# INDIANA DEPARTMENT OF TRANSPORTATION

### STANDARDS COMMITTEE MEETING AGENDA

RE: Agenda for the April 13, 2006 Standards Committee Meeting

REVISION TO 2006 STANDARD SPECIFICATIONS

503-CCPS-01

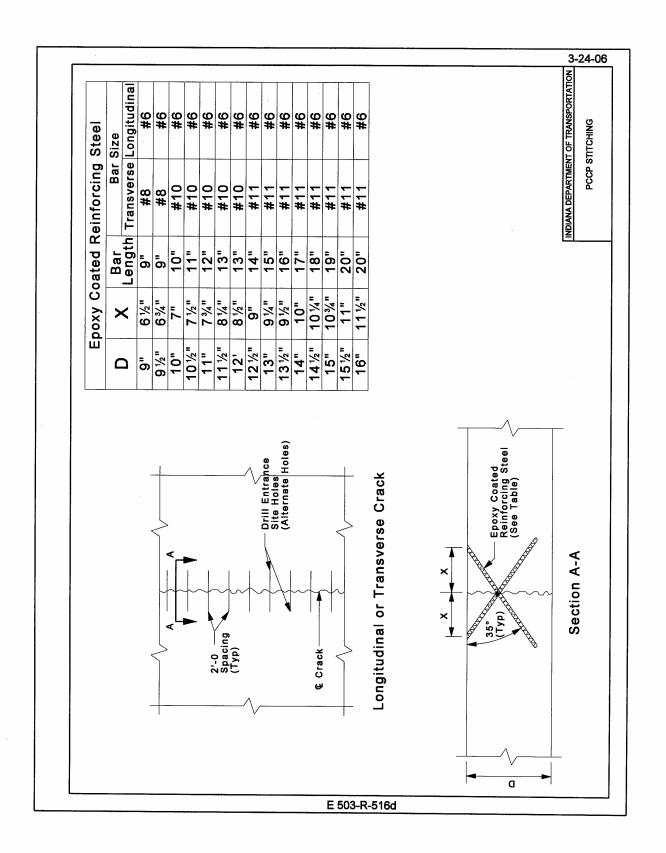
Item No. 11-5 Mr. Kuchler Date: 4/13/06

# REVISION TO 2006 STANDARD DRAWING

# 49-5.01(04) Guardrail and Embankment Slopes

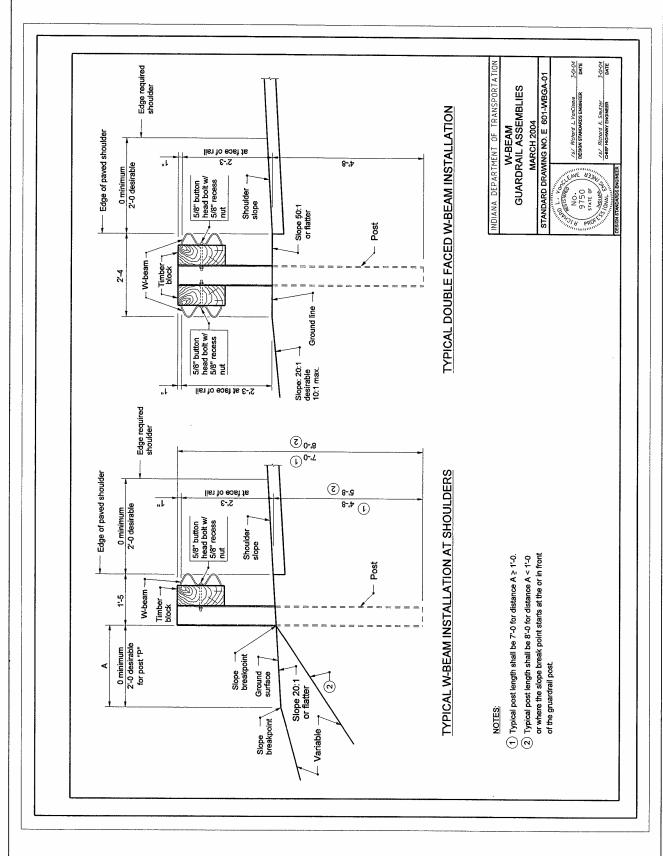
The policy relating to required guardrail post embedment length on a graded shoulder has been changed.

- 1. A 0.6 m (2'-0") distance is desirable on a graded shoulder as measured from the back face of guardrail post before the shoulder slope break point.
- 2. Where this distance is  $\ge 0$  3.m (1'-0"), the guardrail post length for this condition is 2.31 m (7'-0"). A standard W-beam guardrail post should be used.
- 3. Where this distance is < 0.3 m (1'-0"), the guardrail post length for this condition is 2.43 m (8'-0").
- 4. The embedment for guardrail post must be in cohesive or cohesionless (sandy) soil. Where located in an aggregate wedge, the 2.43 m (8'-0) post should be used.

A semirigid barrier should not be placed on a slope steeper than 10:1. However, no barrier should be placed on any slope steeper than 6:1.

The guardrail post embedment length must be appropriate either in cohesive or cohesionless (sandy) soil. The INDOT Standard Drawings present the criteria for location of the guardrail post and the required post embedment length for the corresponding location of the post on a graded shoulder. A 0.6 m (2'-0") distance on the graded shoulder, before the shoulder slope break point as measured from the back face of the guardrail post is desirable for adequate soil foundation support. Where site conditions allow 0.3 m (1'-0") or greater graded shoulder width to be constructed, the guardrail post length is 2.13 m (7'-0"). Where site conditions allow less than 1.0 m (1'-0") graded shoulder width to be constructed, the guardrail post embedment length should be increased to 2.43 m (8'-0") to compensate for the reduced soil foundation support.

Where guardrail posts must be placed on steep shoulder slopes (1:1 or 2:1) or in aggregate wedges adjacent to the edge of the effective usable shoulder, 2.43 m (8'-0") post, discussed above should be used to provide adequate foundation support for the guardrail.

601 WBGA-01 W-Beam Guardrail Assemblies 601-WBGC-03A W-Beam Guardrail Components

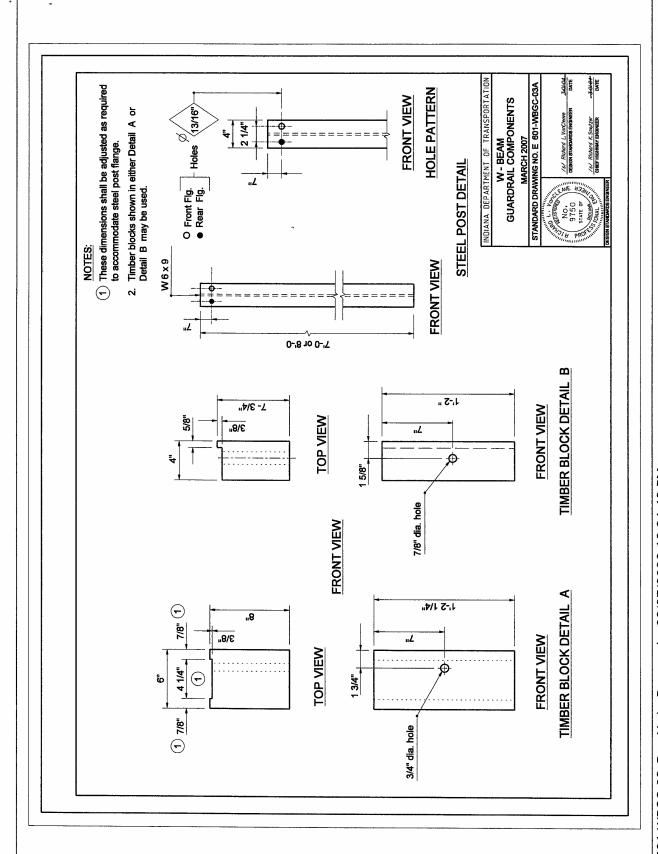
# REVISION TO 2006 STANDARD DRAWINGS
